# **ADDENDUM #1**

**BL000A SITE - CAMPUS RIVER RESTORATION**  
**PROJECT NUMBER – IU 20230520**  
**STABILIZATION AND MAINTENANCE**

## Campus River Phase III - Addendum #1

# CAMPUS RIVER PHASE 3

C2.2

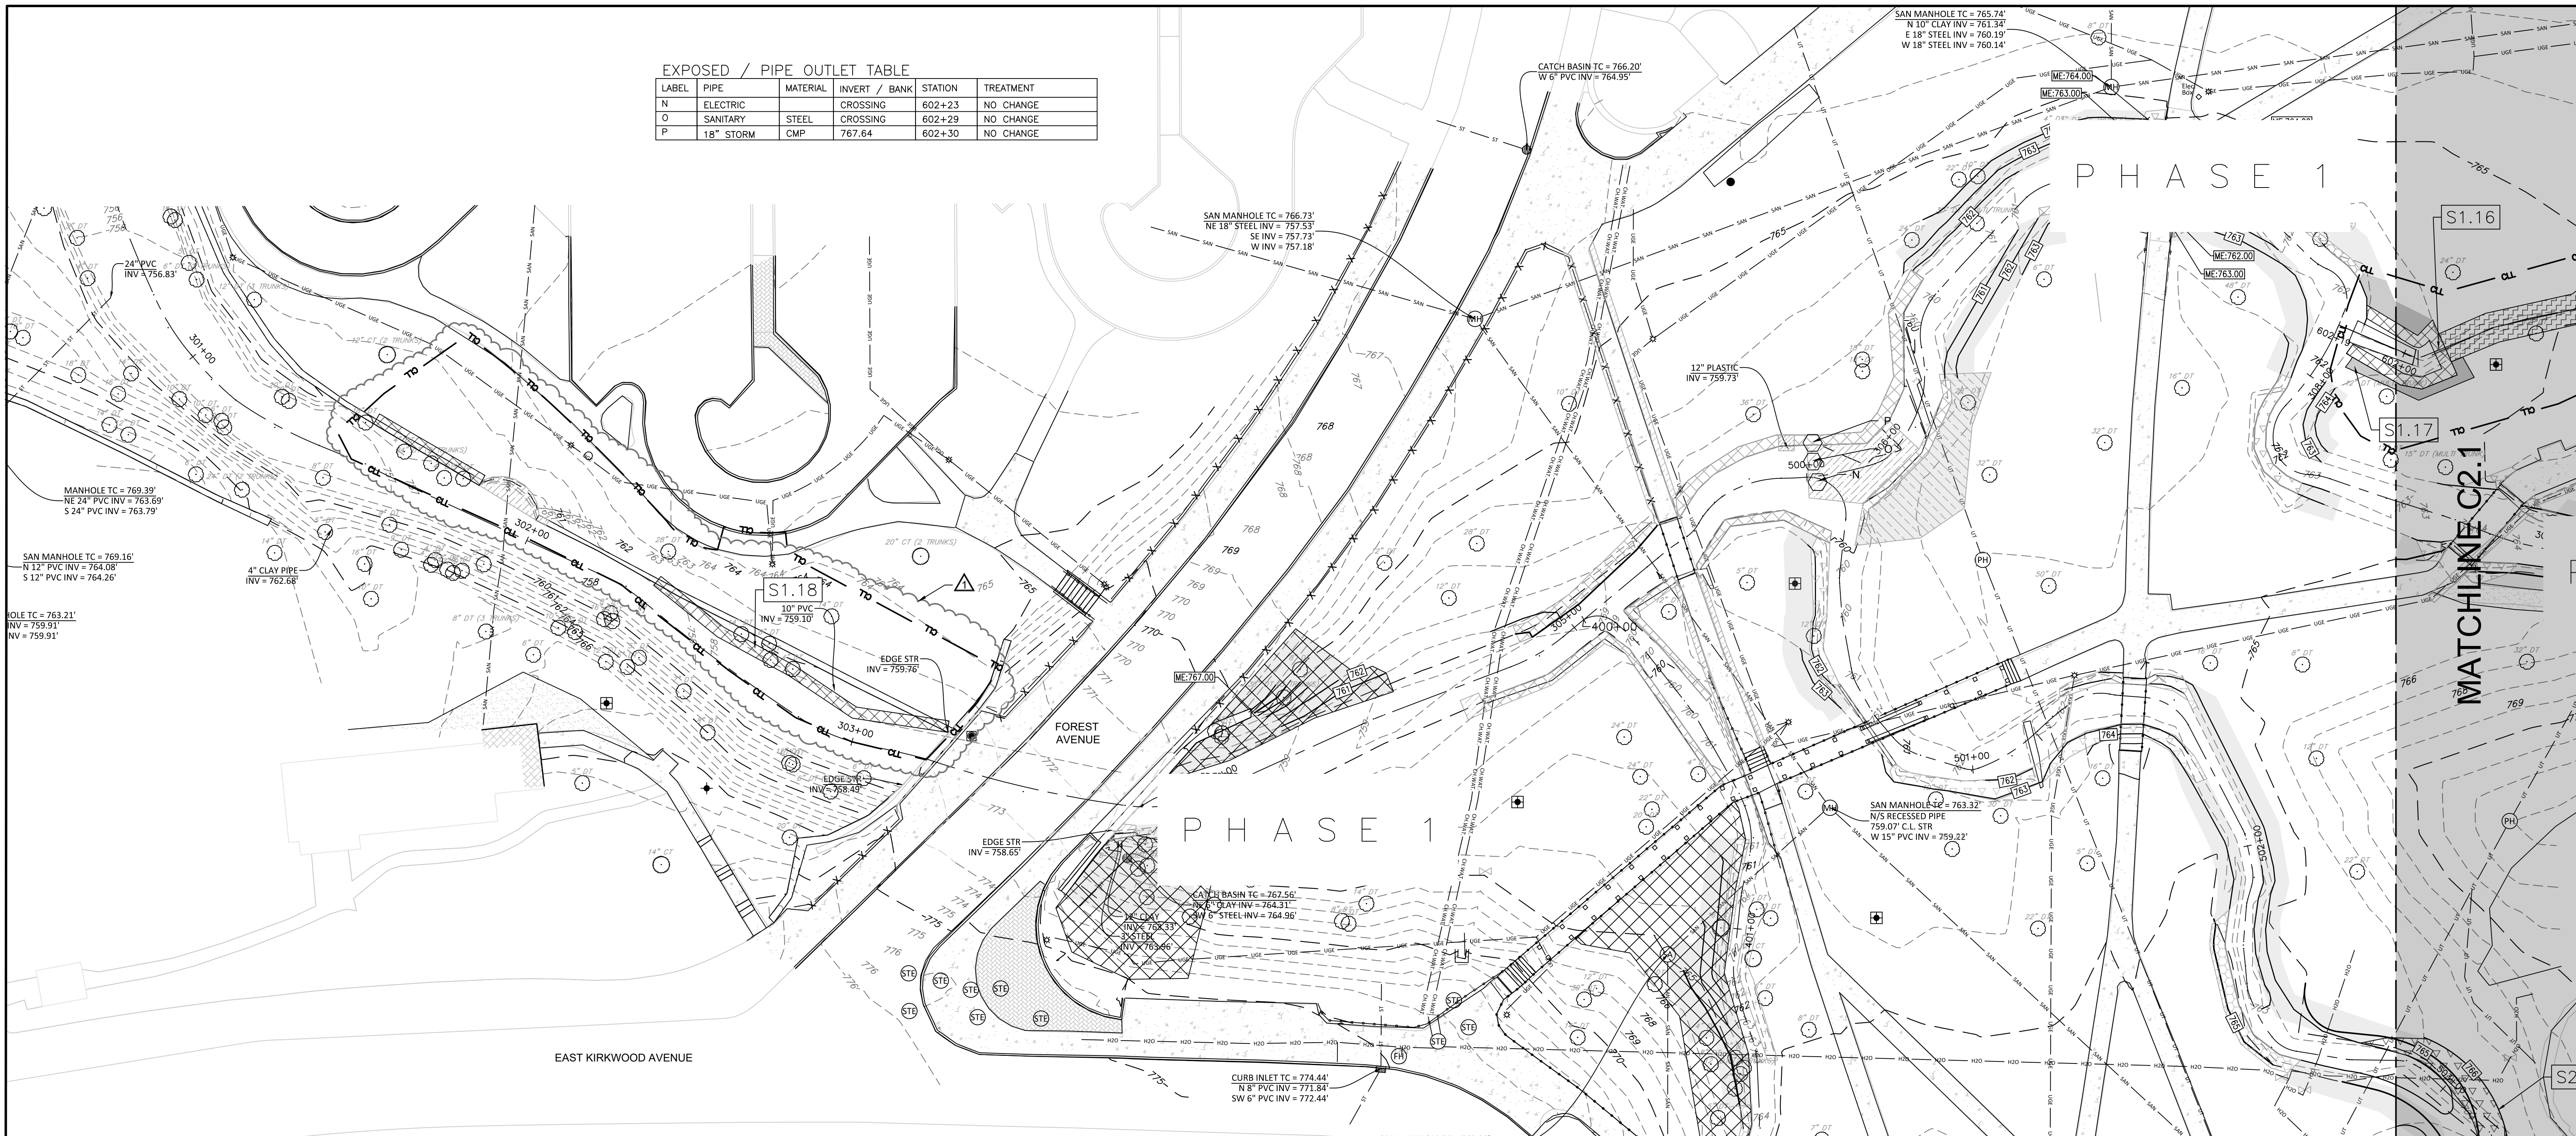
- There were questions about the limits of the wall reconstruction downstream of the Forest Avenue Bridge.
  - Due to recent repairs of portions of the wall, Addendum #1 includes an updated depiction of the limits of the 100' of repair listed in Alternate 1. Rather than being 1 continuous repair 100 feet in length, the 100 foot repair will be split into 2 segments as described and shown in plan view.

- Will Fencing be required around the construction limits of S1.18?
  - Fencing has been added to the plans to protect the public for the improvements associated with S1.18.

ALTERNATE #1  
S1.18 - REPAIR EXISTING MASONRY WALL.  
UNSTACK, NUMBER, CATEGORIZE AND CLEAN GROUT FROM STONE FROM EXISTING WALL AND STOCKPILE ON NORTH BANK BETWEEN THE EXISTING WALL AND PARKING LOT. WHEN RECONSTRUCTING, WALL HEIGHT SHALL REMAIN CONSISTENT, AND STONE THAT IS IN NEED OF BEING REPLACED TO BE REPLACED WITH STONE OF SIMILAR SIZE SHAPE, COLOR AND FINISH OF SURROUNDING STONE. DRAINAGE SYSTEM TO BE INSTALLED BEHIND WALL AND DISTURBED AREA TO BE RESTORED WITH CLEAN TRANSITION TO TOP OF WALL UPON COMPLETION.  
WALL REPAIR TO BE COMPLETED IN 2 SEGMENTS, SEGMENT 1 TO EXTEND BETWEEN FOREST AVENUE BREIGE AND WALL REPAIR COMPLETED PREVIOUSLY NEAR STATION 302+00.  
SEGMENT 2 TO EXTEND FROM WEST EDGE OF RECENT REPAIR. (TOTAL LENGTH 100 LF)

**Z**  
C8.1  
LIMESTONE BLOCK BENCH WITH ROUGHBACK STONE RETAINING WALL  
NOT TO SCALE

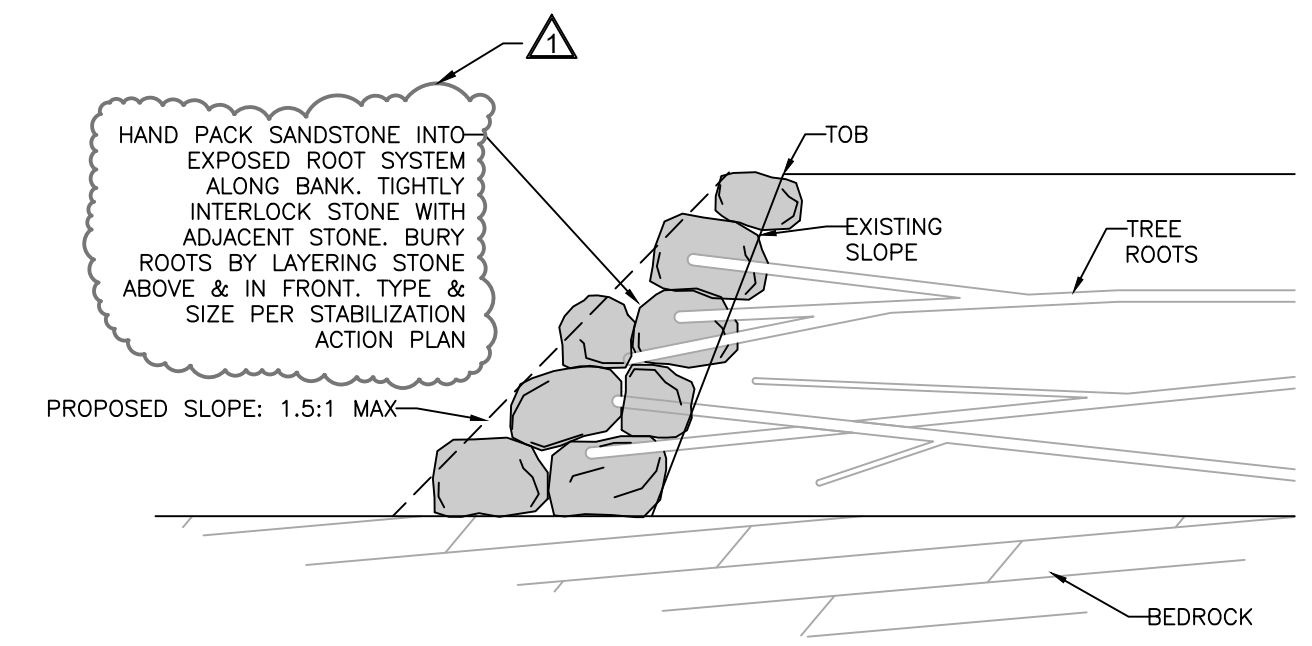
- In Detail Z, #53 stone is the only material listed for the base and top dressing. Is that correct or will a different material be used for top dressing?

- Detail Z has been modified to depict the use of Course L stone for the top layer.

**Y**  
C8.0  
CONCRETE PAVEMENT SECTION  
NOT TO SCALE

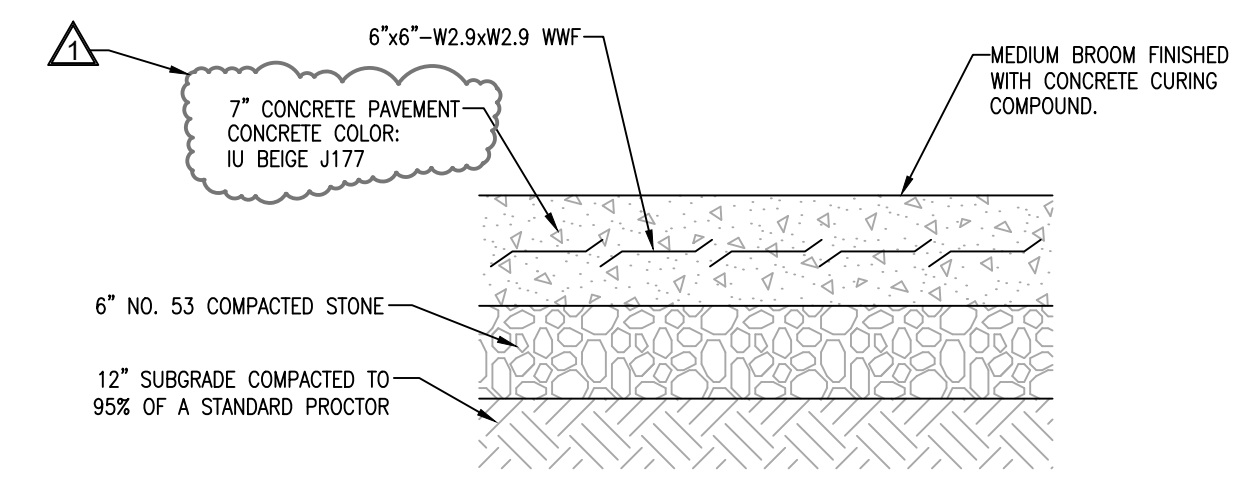
- Substantial Completion – August 15, 2025
- Will all sidewalks be required to use IU Beige color?
  - The contractor is expected to use IU Beige J177. A more detailed concrete specification has been added to the details.
